Energy & Carbon Management Commission

Laramie/0993-29-01 #487592 Annotation Report

Laramie/0993-29-01 #487592 Issue Report

5 - Observation

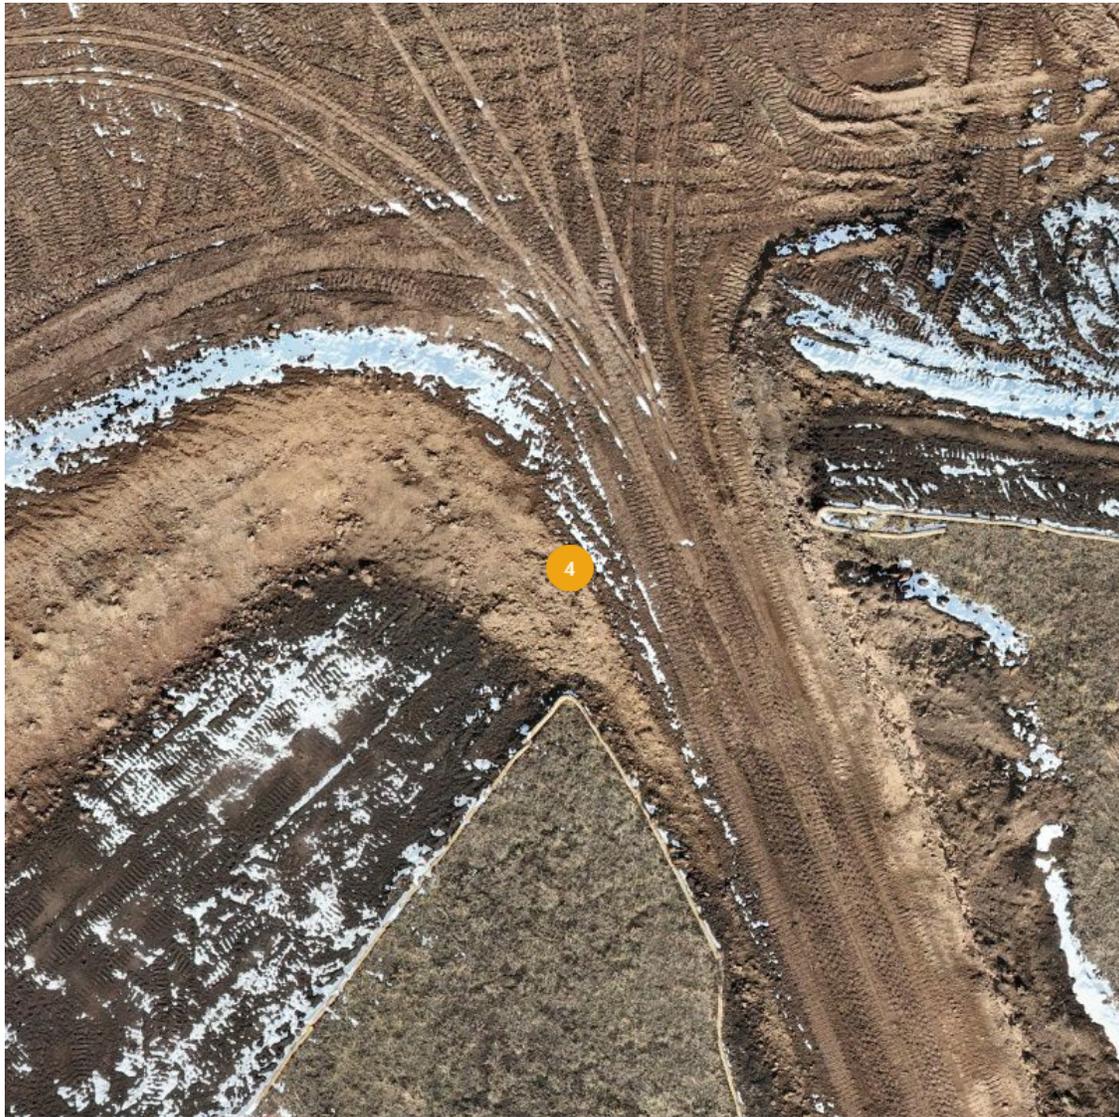
Summary: 24" Culvert in conjunction with "Trap w/ rock armored rundown" not installed per the Form 2A permitted SWMP.
Created: Nov 13, 2024, 7:55am by Aaron Trujillo
Cost of Repair: —
Lat/Long: 39.2531493, -107.7830751
Northing: 1525217.2 US ft
Easting: 2353560.3 US ft
Elevation: 0.59 US ft
NAD83(2011) / Colorado Central (ftUS) (US survey foot)

2 - Observation

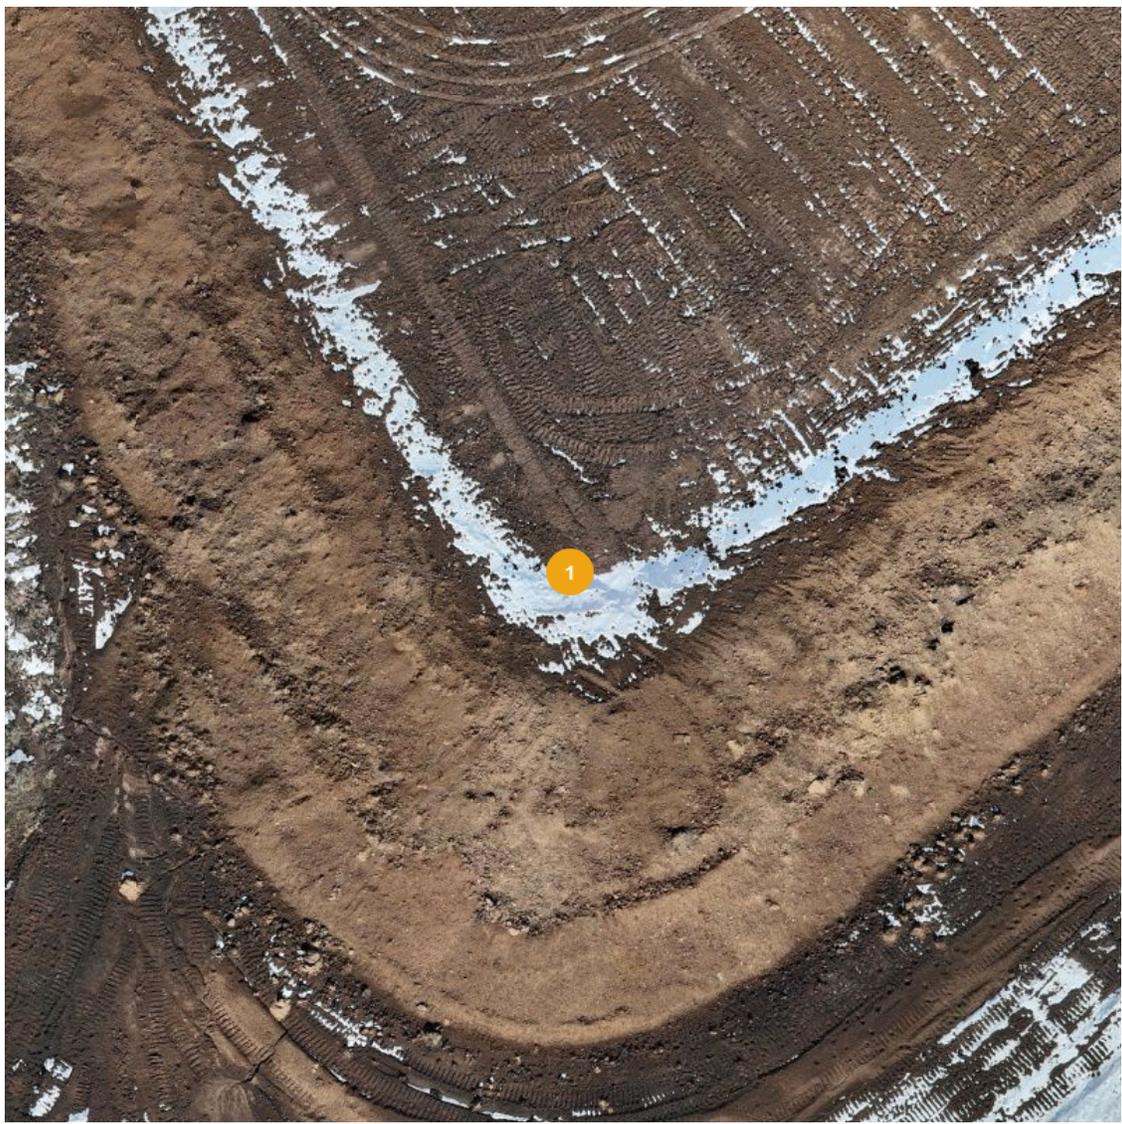
Summary: Flex Pipe w/rock armor inlet/outlet not installed per the Form 2A permitted SWMP and Layout Drawing.
